Mandatory Service Bulletin SB-MD11-006-R02

This Service Bulletin supersedes SB-MD11-006 initial issue and introduces revised operating restrictions for the propulsion system installed in the JS-MD 3 RES aircraft.

Figure 1: Placard to be applied over RES Master Switch

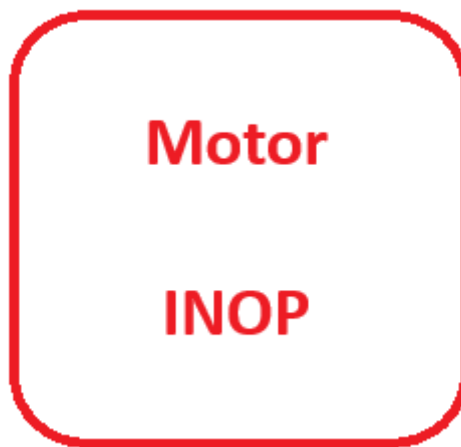
1. Remove MD11-AFM-00-002 JS-MD RES Aircraft Flight Manual Supplement from the aircraft
2. Replace current Flight Manual Issue with MD11-AFM-00-001-I01-R01
3. Remove the High Voltage Batteries from the glider and store using an approved method.
4. Ensure that all battery locks are put back in place.
5. Apply the "Motor Inop" placard over the Master Switch located on the instrument panel to prevent the pilot from activating the system.
6. Apply the "Motor Inop" placard over the engine instrument to indicate to the pilot that the system is not operational.
7. Apply the "Extension of motor prohibited" placard near the RES Master Switch.
